**LODI UNIFIED SCHOOL DISTRICT**

**2020 Paving Project(s) – Phase II**

**Creekside Elementary School**

**ADDENDUM NO. 1**

| <b>PAVING PLAN</b><br><b>CREEKSIDE ELEMENTARY SCHOOL</b><br><b>PAVING</b><br><b>LODI USD</b> |  |                     |  |                       |  |

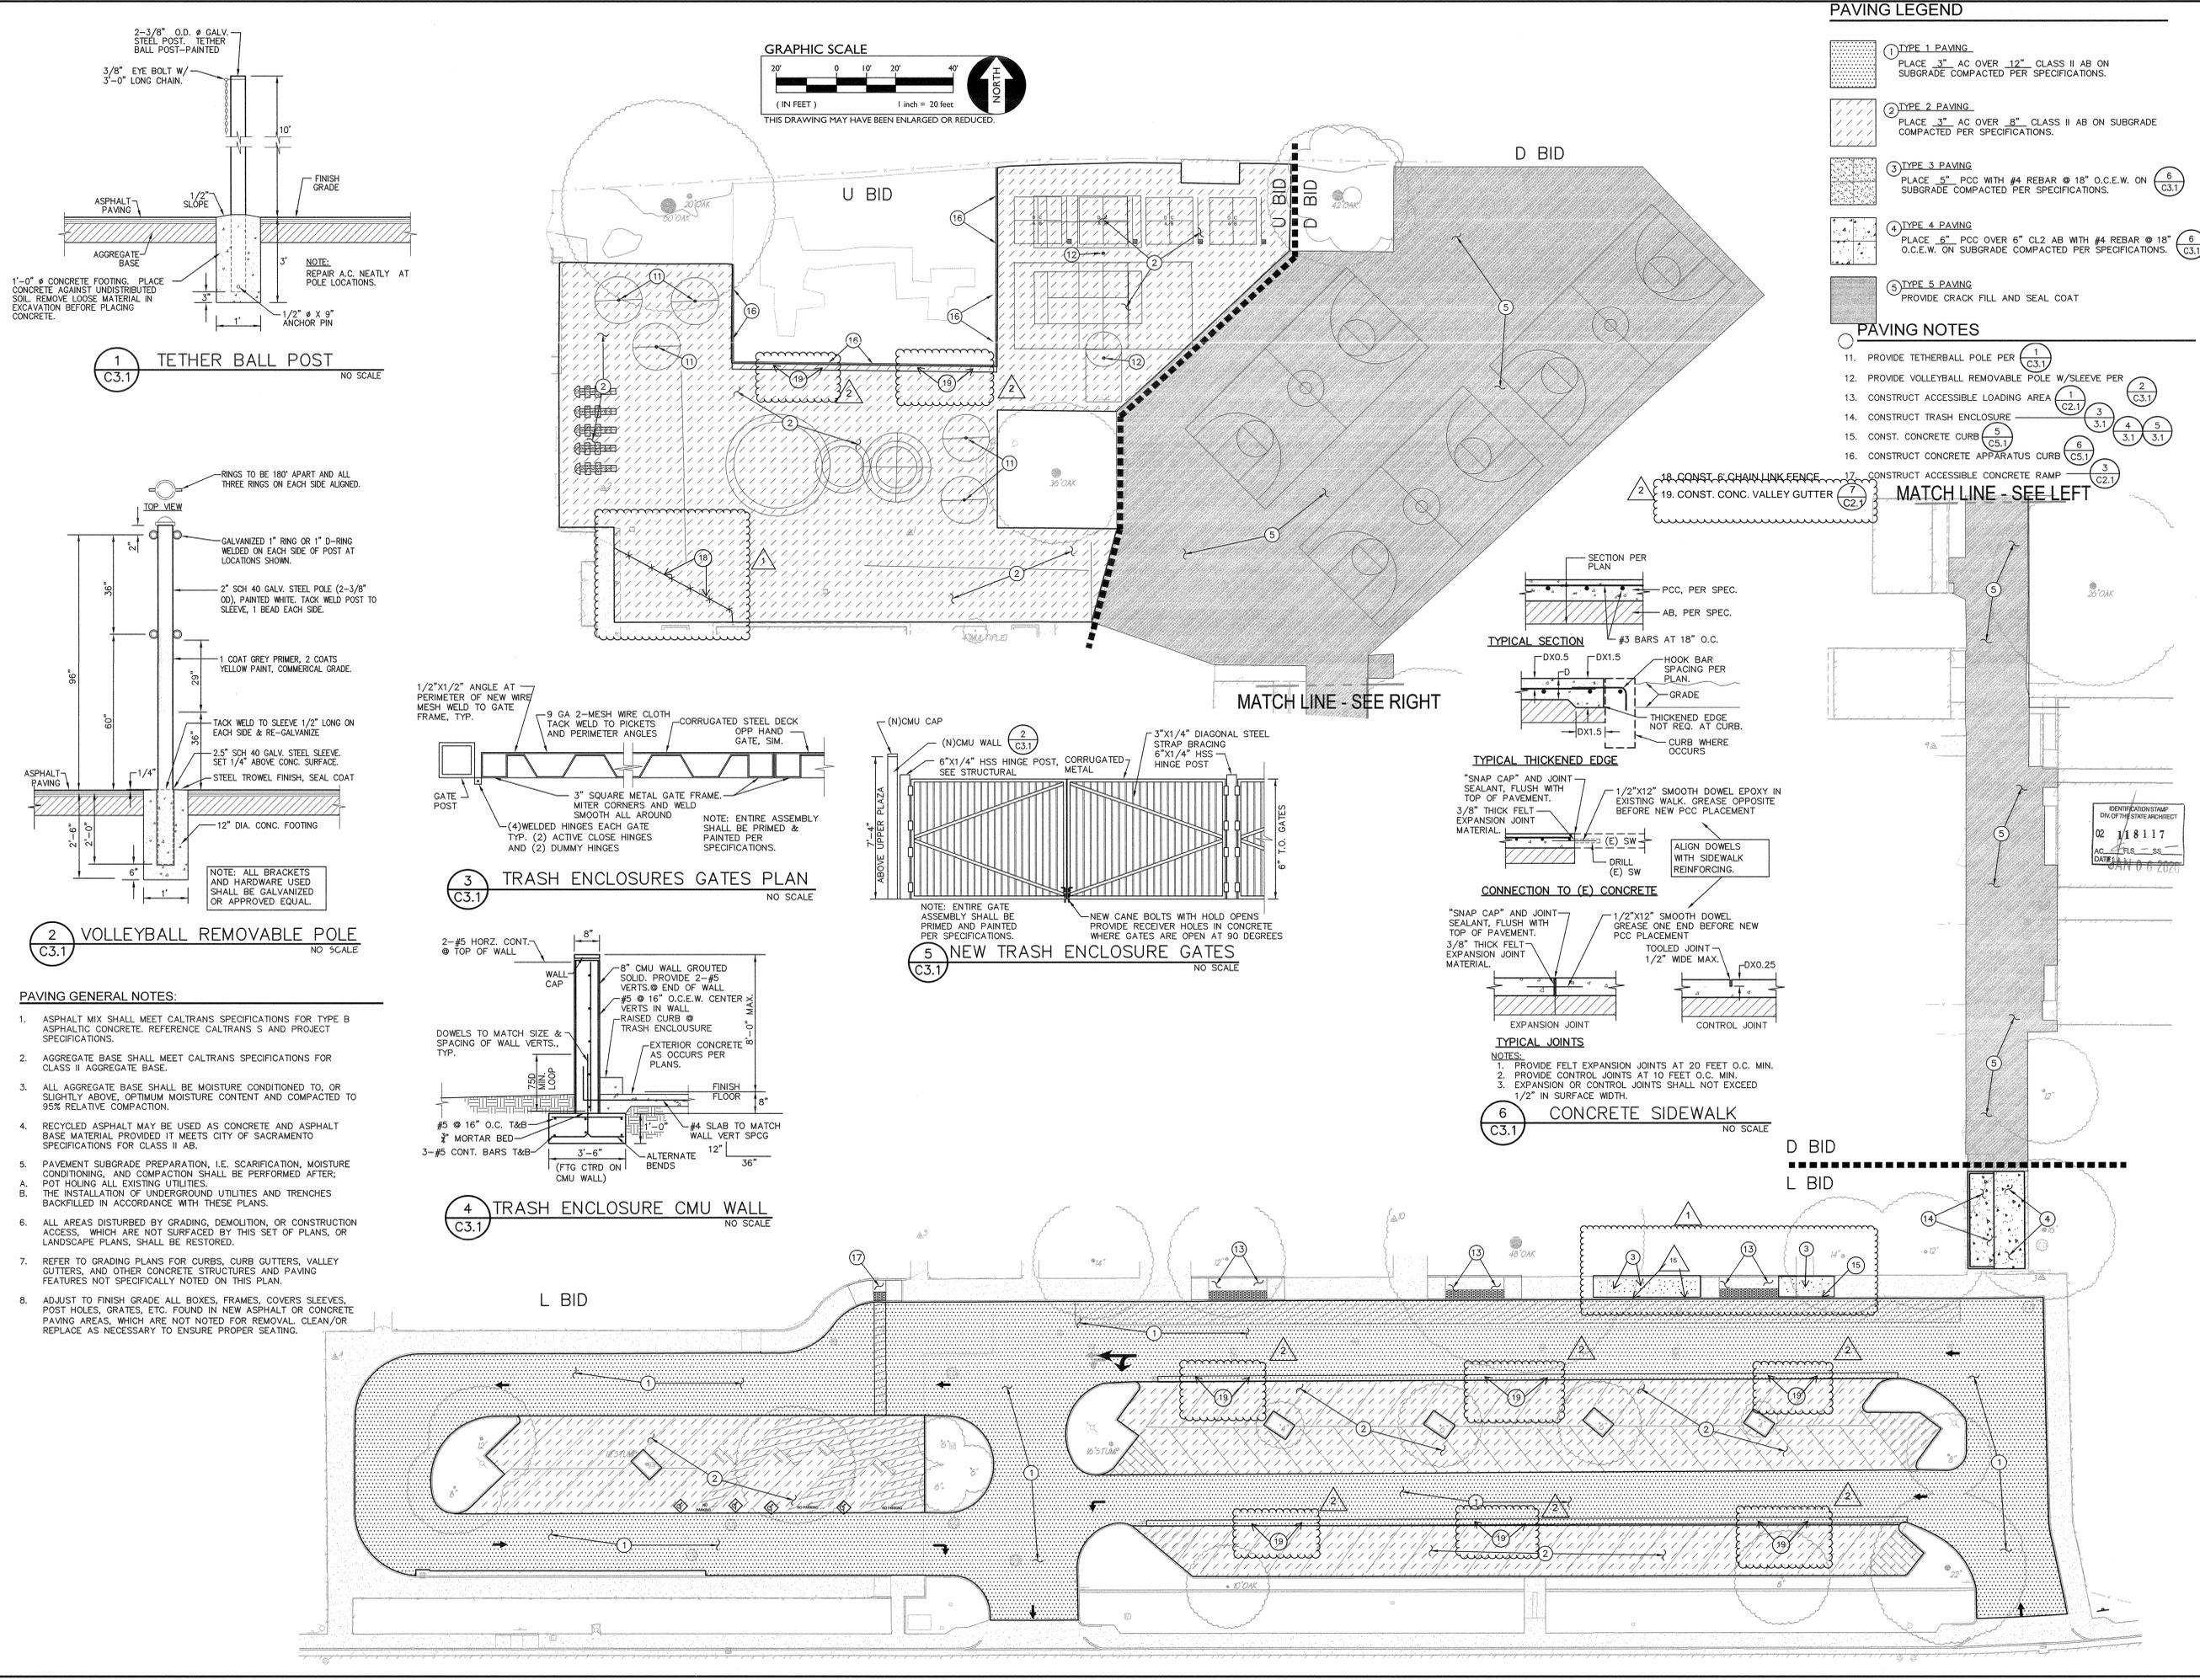
- Response:** The valley gutters are called out on replaced Addendum Sheet C2.1 and C3.1.
- 1.7 **Question:** Will we be replacing the curbs at the ADA ramps. There is no callout for demo and unclear if new curbs are going in.

- Response:** See Addendum Sheet C3.1.
- 1.8 **Question:** C3.1 note 18 appears to point to new fence replacing the demo'd fence in the playground but there is no note 18. Please advise.

- Response:** See Addendum Sheet C3.1.
- 1.9 **Question:** The limits of the concrete ramp are unclear on the grading sheet compared to the civil sheet. Please advise which will govern.

- 1.4 Creekside Elementary School - Project #0913-8213 – DSA #02-118117. Refer to Drawing Sheet C2.1 Grading Plan. **Replace** in its entirety with Drawing Sheet C2.1 Grading Plan, dated 03/12/2020.
- 1.5 Creekside Elementary School - Project #0913-8213 – DSA #02-118117. Refer to Drawing Sheet C3.1 Paving Plan. **Replace** in its entirety with Drawing Sheet C3.1 Paving Plan, dated 03/12/2020.

SFMH48  
STORMFILTER  
STANDARD DETAIL

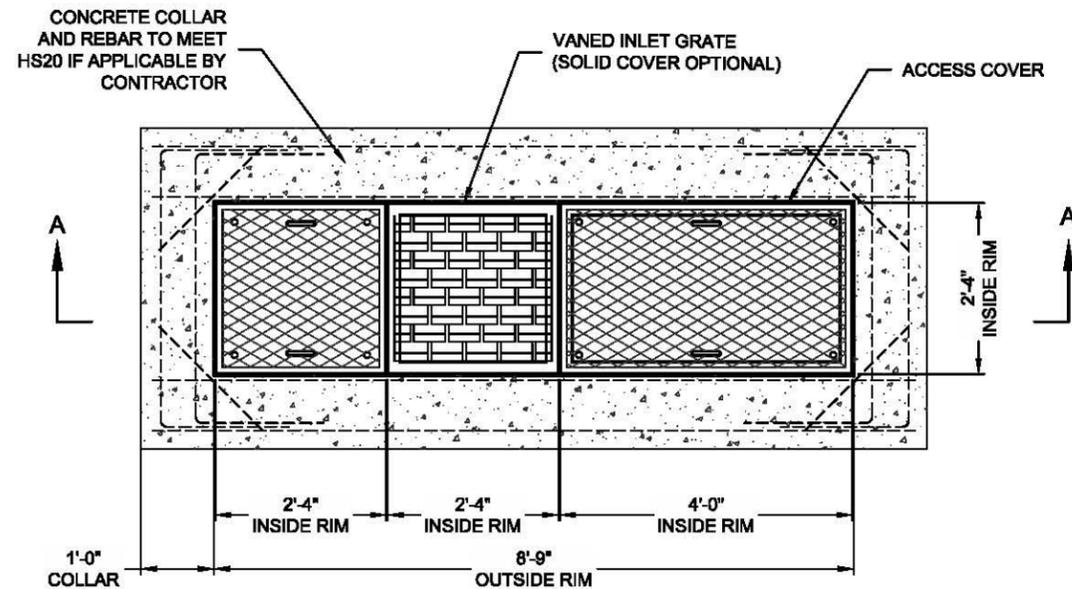
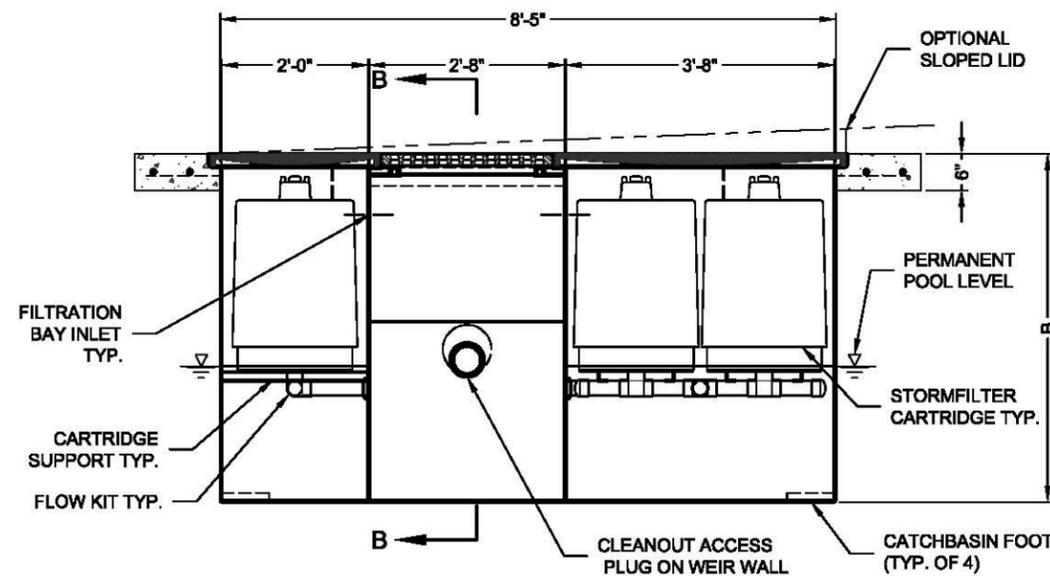
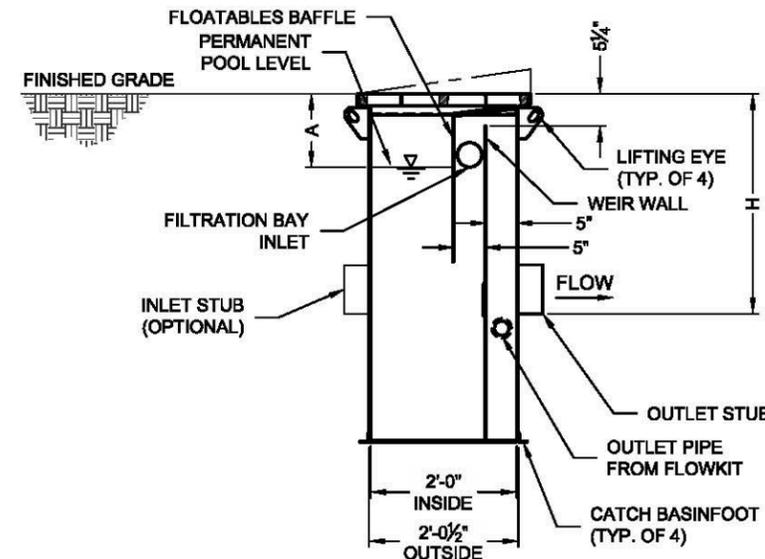
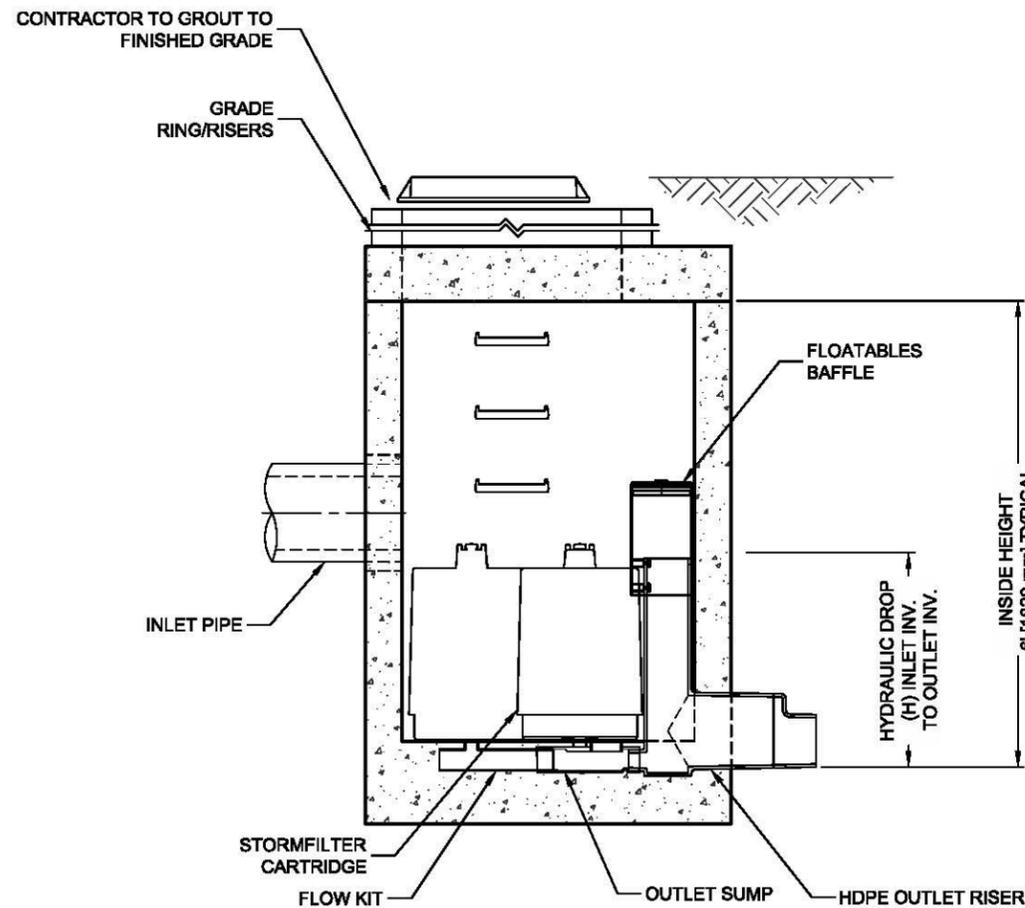
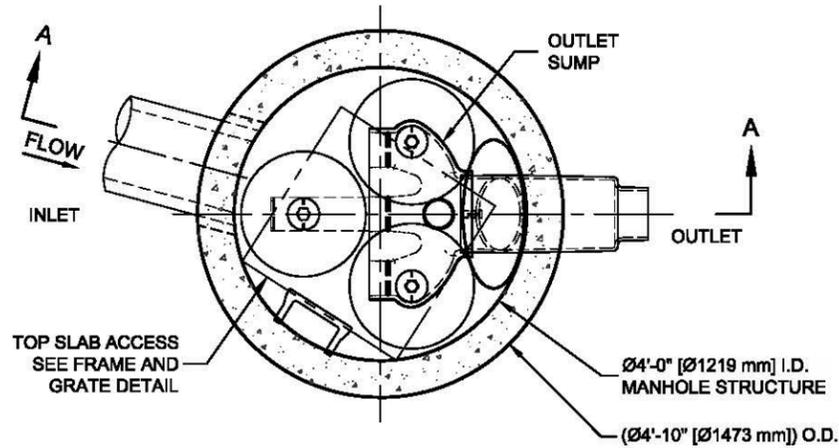
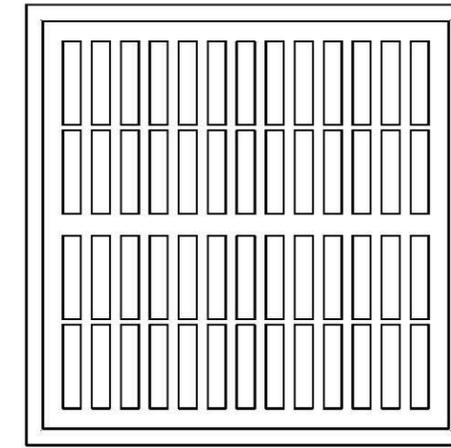
1.15 **Question:** Please provide a detail for the Contech units.

**Response:** See Contech Units sizing submittal attached to this Addendum No. 1.
